PRODUCT/ PROCESS CHANGE NOTIFICATION					
1. PCN No.:	QPCN11005				
2. Subject:	KBL 4A, 6A Series,				
	change manufacturing location				
3. To:	All Sales

4. Issued by:	Owen Wang				
5. Issue date:	23 rd Feb., '11				
6. Proposed first ship date for change:	26 th May, '11				
7. Affected Product Identification					
GPP bridge rectifiers devices: KBL401G thru KBL407G (4A) KBL601G thru KBL607G (6A)

A (Outline dimensions & Appearance):

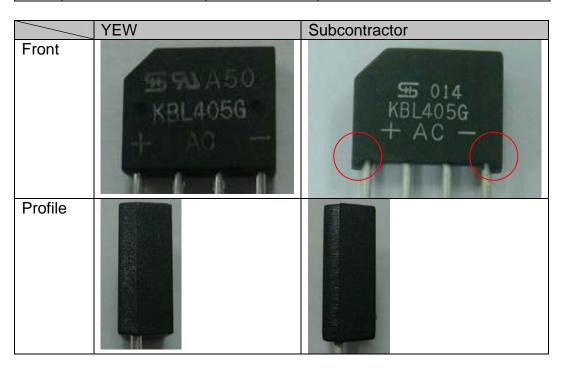
8. Change Description : (OLD Vs. NEW Con	nparison)				
Old:	New:				
Manufactured at Taiwan Semiconductor YEW plant.	Manufactured at outsource supplier in China.

9. Reason for Change:					
10. Anticipated Impact: (form, fit, function, quality or reliability) 1. Product outline changed 2. Inner construction changed 3. Electrical specifications: 4. Reliability/performance: 5. Data sheet: 6. Packing code (order code): No change Changing version from E10 to E11 No change
